City of Keene, New Hampshire
Historic District Commission

COA-2019-07, Modification #1 – 89 Main St. – Alterations to Colonial Theatre Addition

RE: Update to COA 2019-07
Expansion of Colonial Theater

1 North Elevation HDC
1/4" = 1'-0"

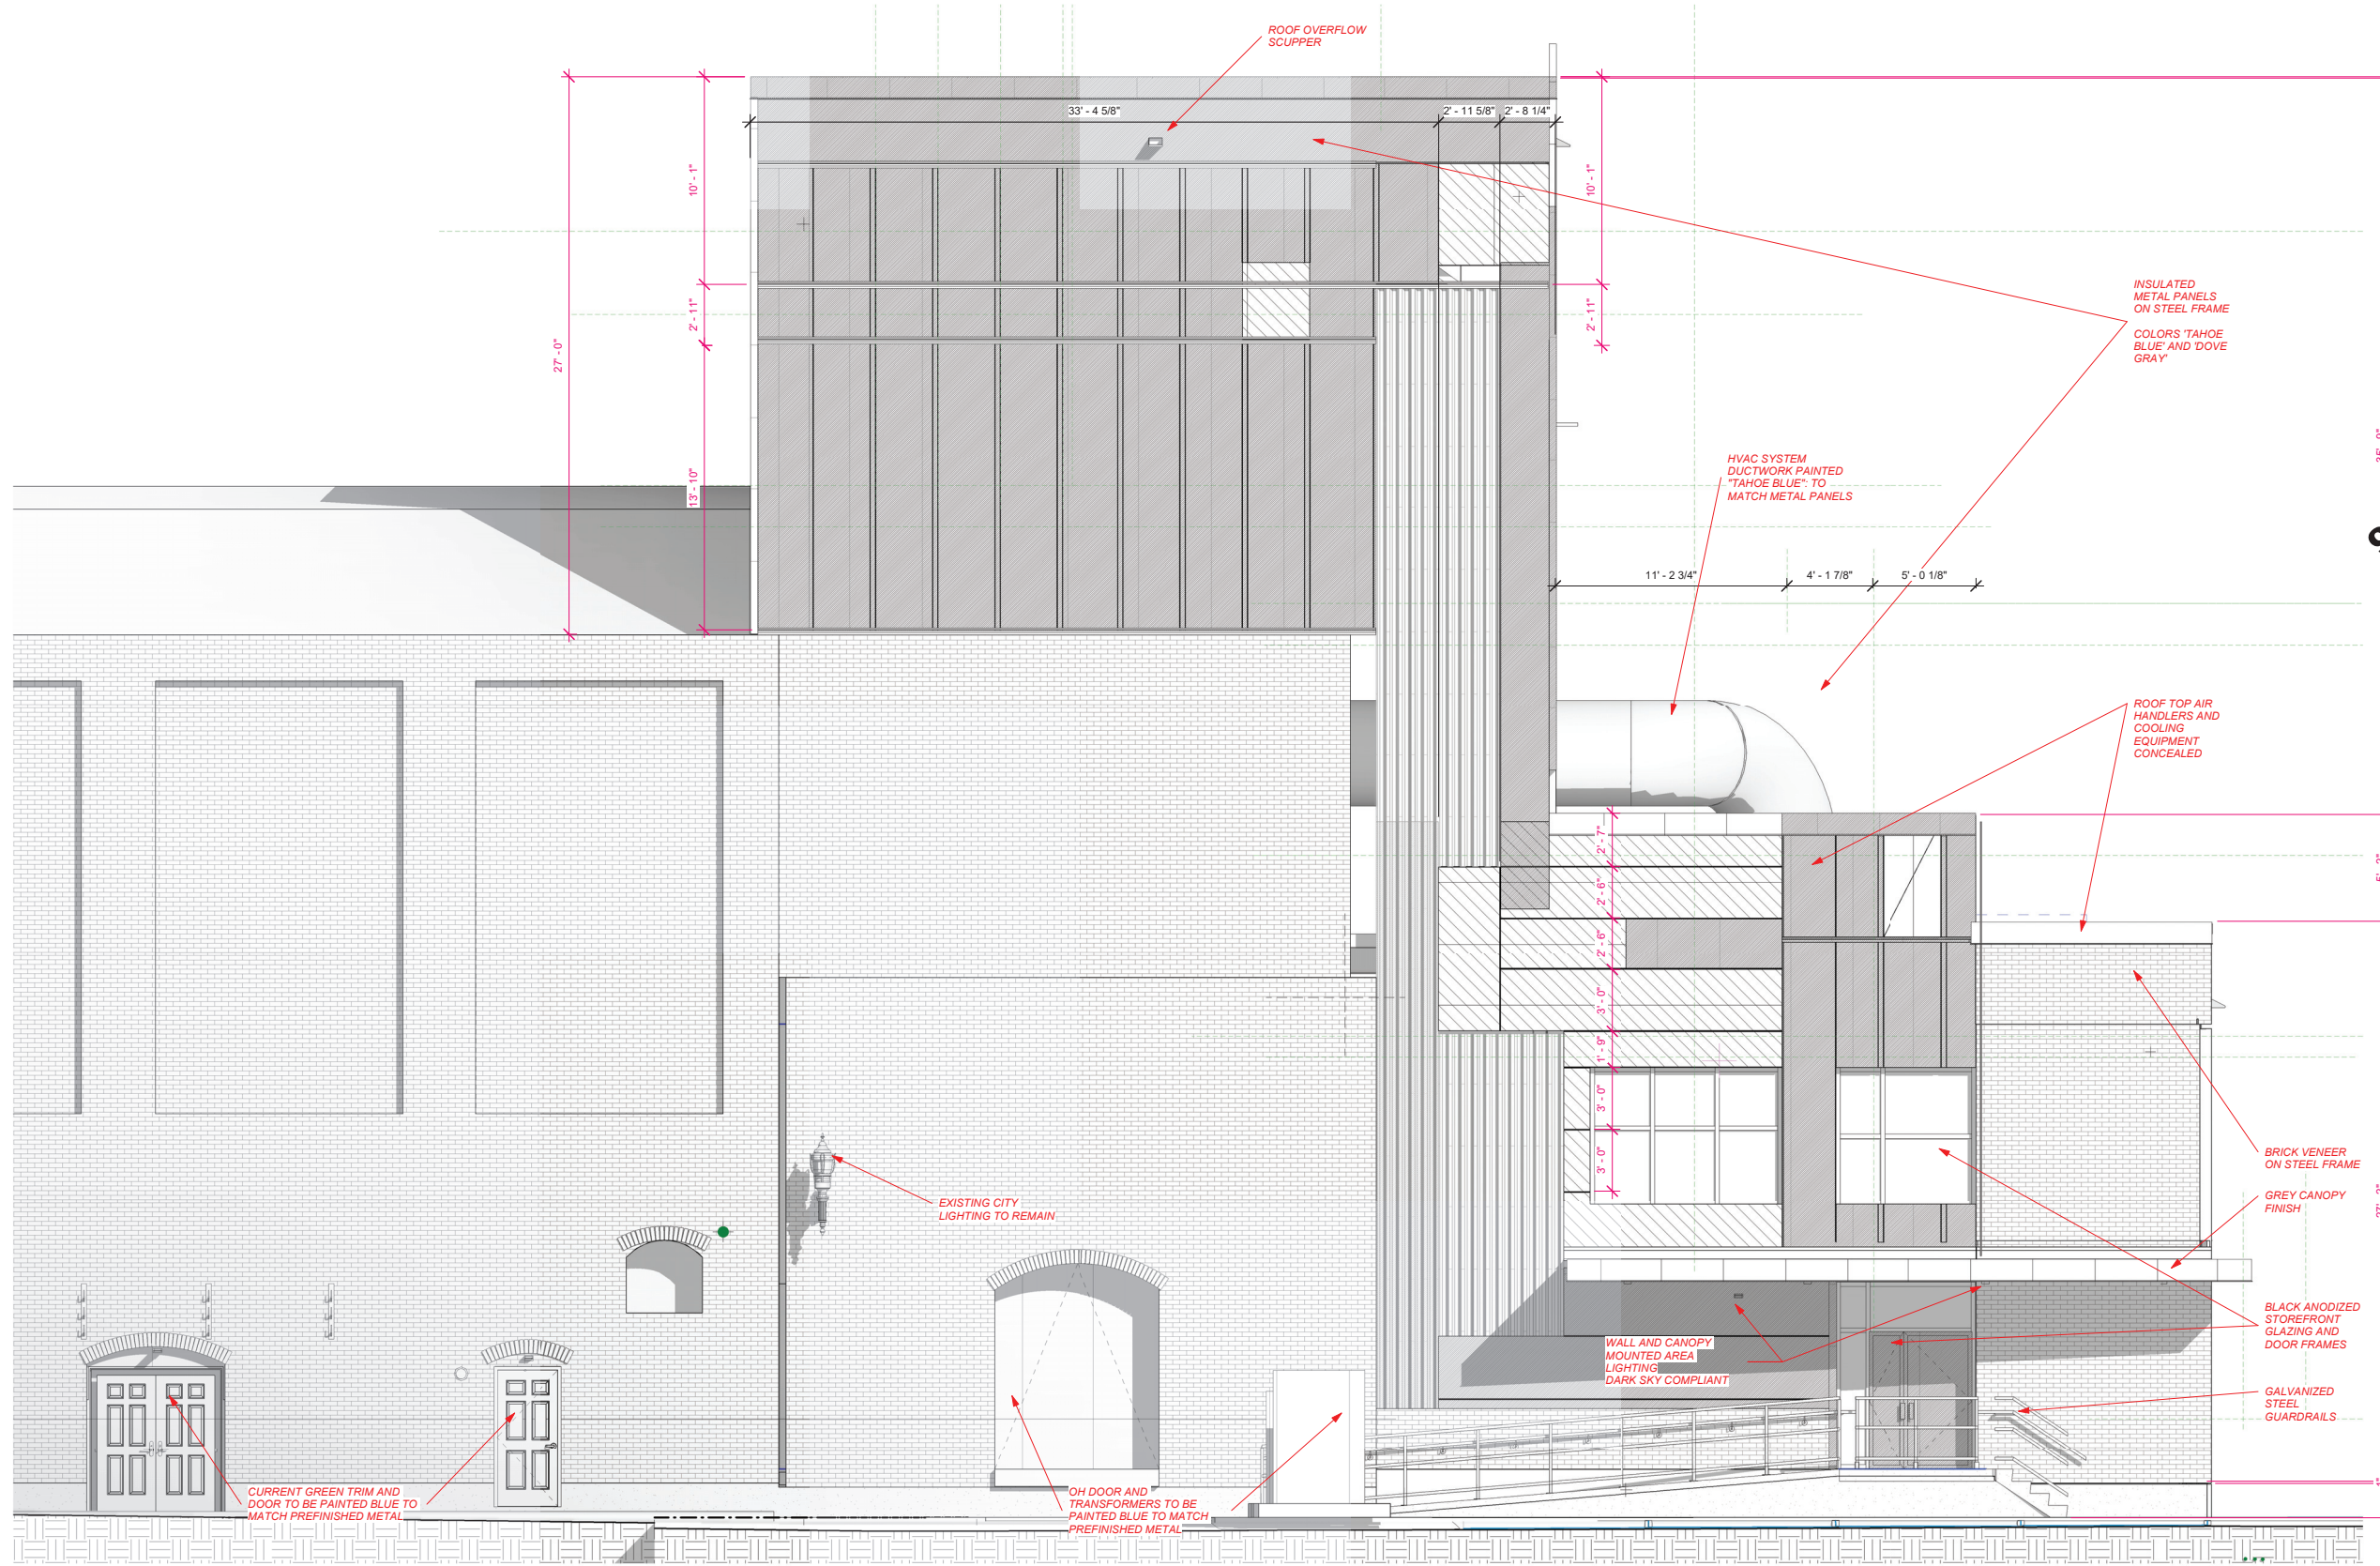
The current request is to reduce the height of the addition to be 69 feet and 10 inches above grade, or 12 feet taller than the existing structure. Since this request would reduce the height of the addition, it would be slightly more in keeping with the size and scale of the main building. This standard appears to be met.

The HDC previously approved two different siding materials for the new addition, including an insulated metal wall panel system (prefinished steel and/or aluminum) painted in shades of blue and gray and a brick veneer. No changes are proposed to the brick veneer product; however, the Applicant does propose to modify the layout/arrangement of the metal panels and increase their size relative to the original proposal that was approved by the HDC. The differences in the metal panel layout/arrangement, sizes, and texture can be seen in Figures 2 and 3 as well as in the architectural elevations, which are attached to this staff report. In the project narrative, the Applicant states that "The smaller discrete 'rain-screen' panel sizes planned and illustrated in COA-2019-07 have proved to be unachievable within the project budget, and the new layout uses both smooth-skinned and more three-dimensional textured skin panels to achieve project goals."

Approve COA-2019-07, Modification #1 for modifications to the Colonial Theatre addition, as presented in the architectural elevations identified as "Building Elevations COA Application, 2021 Addition and Renovation, 95 Main Street Keene, NH" prepared by Weller & Michal Architects at a scale of 1/4" = 1'-0" and dated December 1, 2020 with no conditions.

1 West Elevation HDC
1/4" = 1'-0"

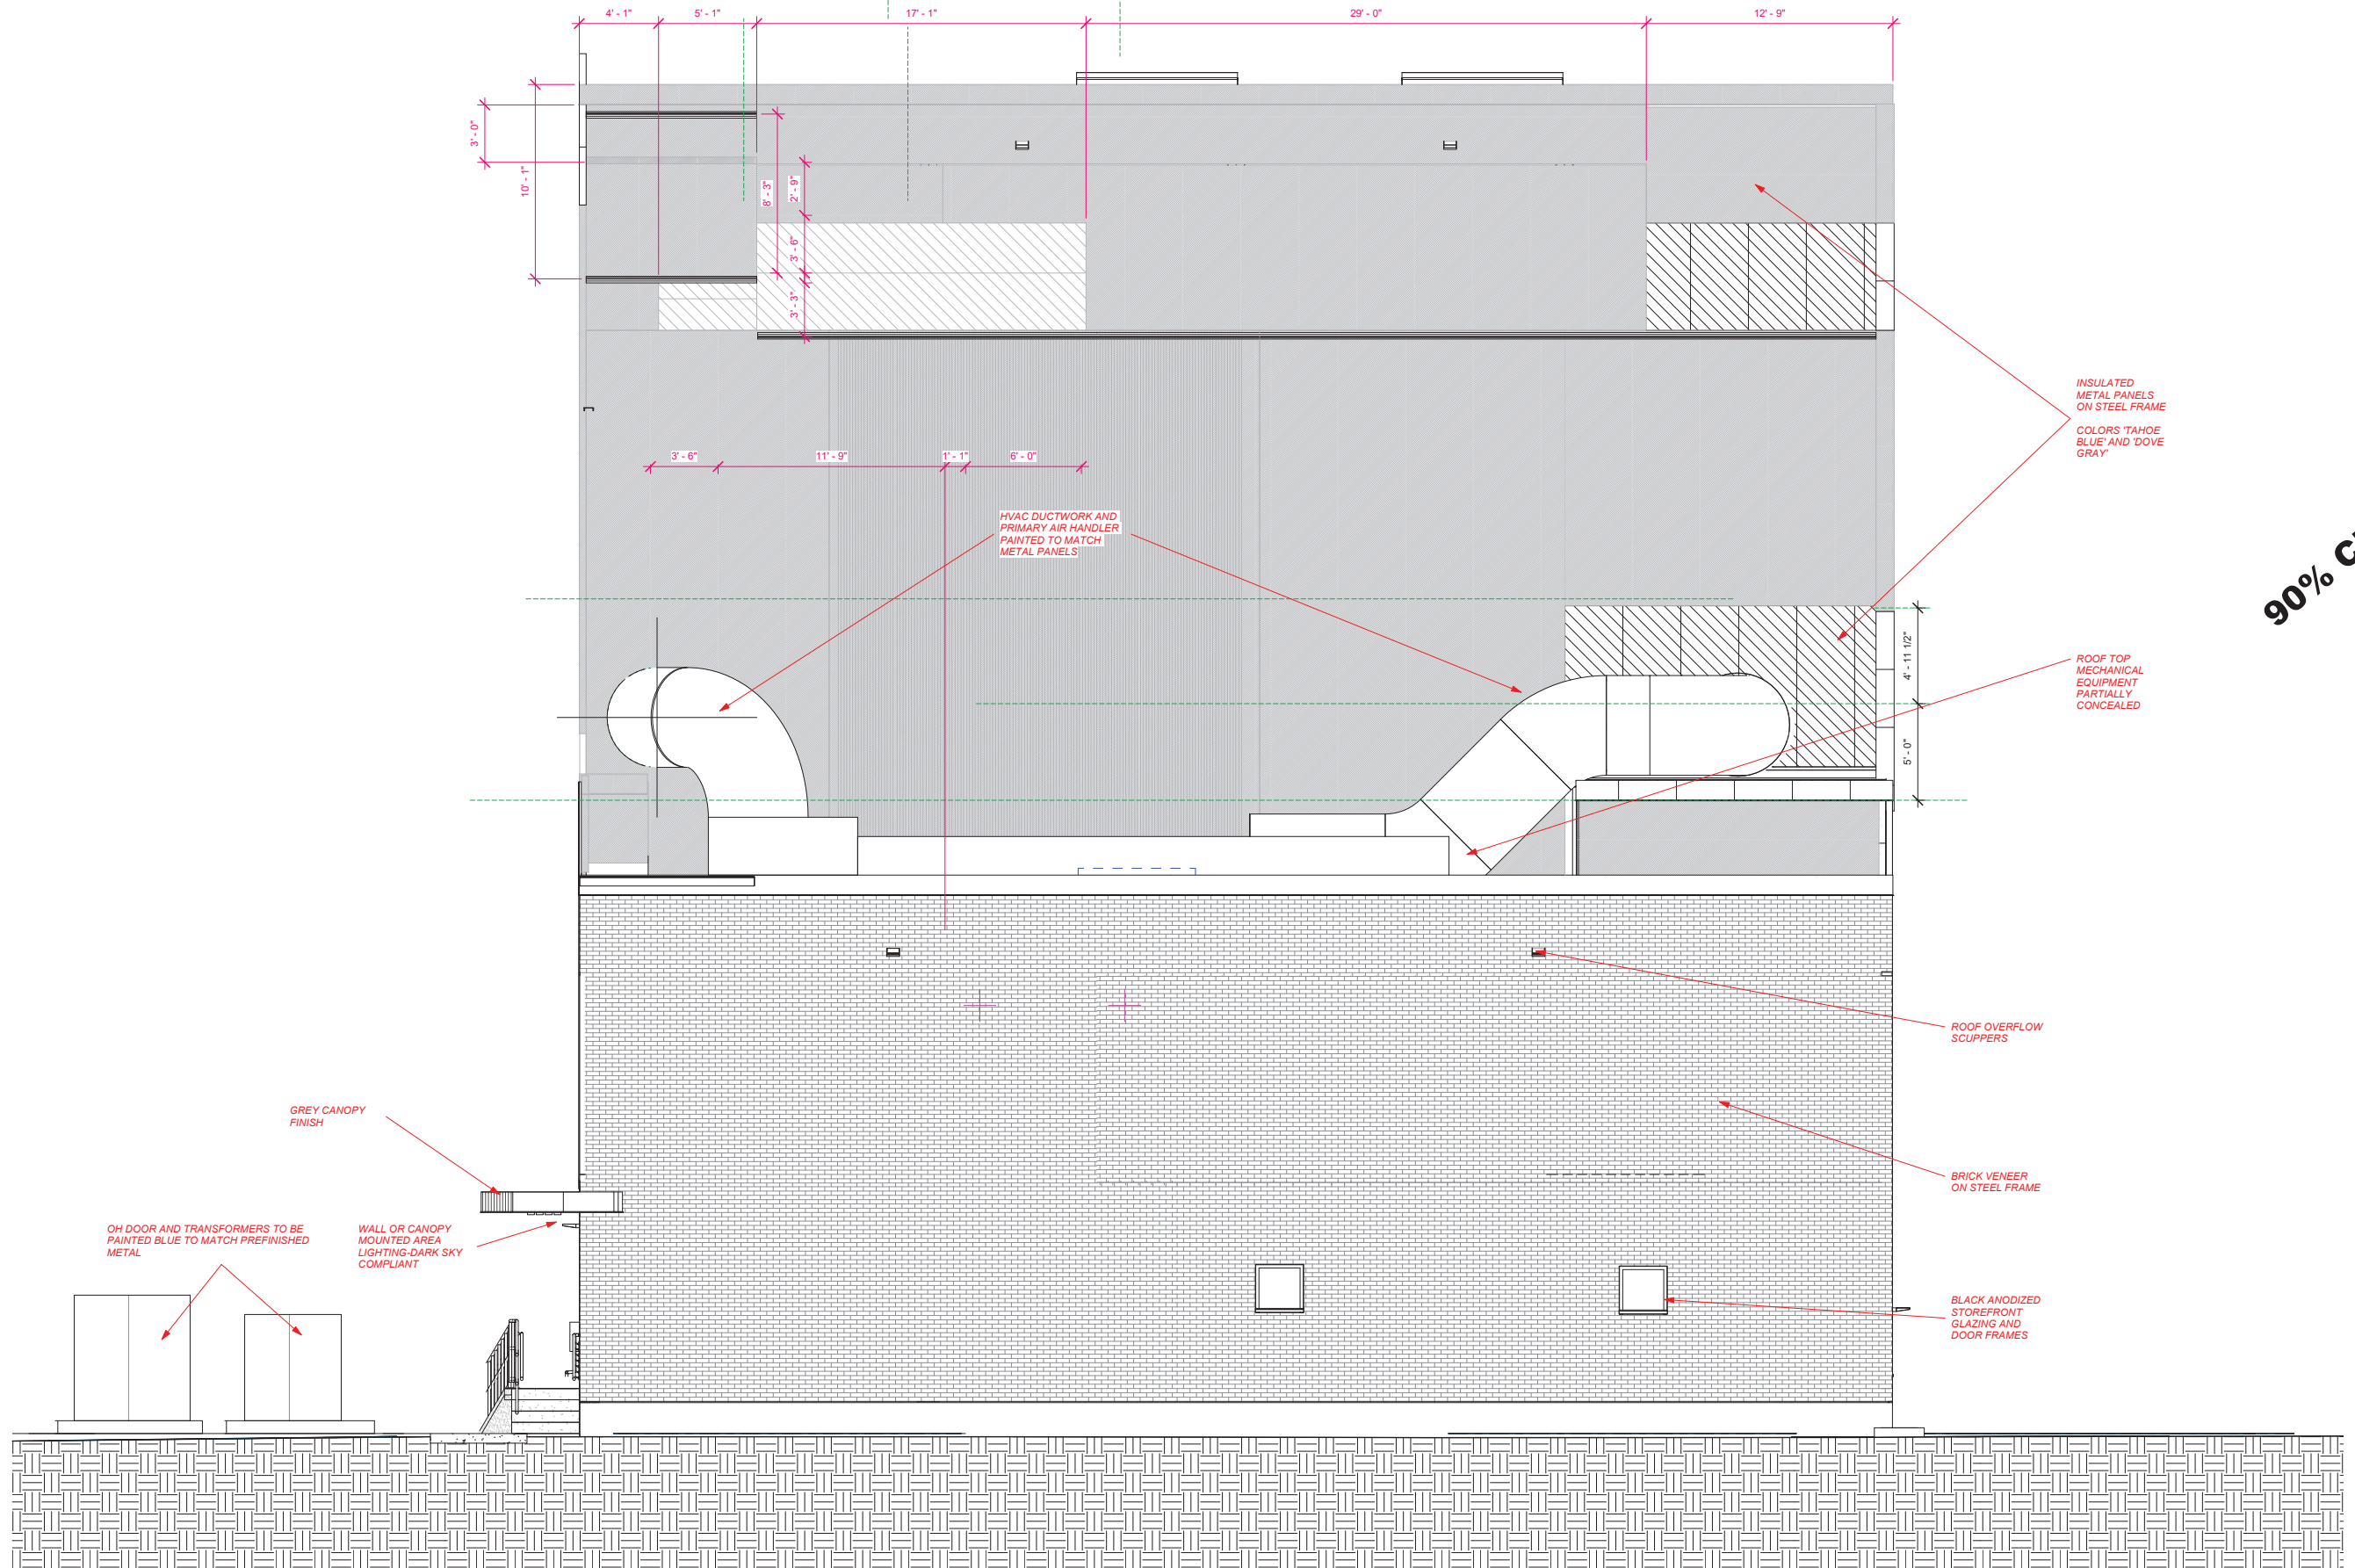
In 2019, the Applicant received approval from the HDC to place all mechanical equipment and ductwork within an enclosure that would completely screen the equipment from view, as shown in Figure 2 on the next page. Due to budget constraints, the Applicant proposes to install the mechanical equipment and ductwork on the roof of the addition, rather than place it inside an enclosure. The equipment and ductwork would be partially screened by parapet walls on the south wall (4-ft above roof surface), west wall (4-ft above roof surface), and north wall (9-ft above roof surface). The portion of the ductwork and equipment that would be visible would be painted to match the siding of the new addition to minimize visibility, as shown in the color rendering in Figure 3.
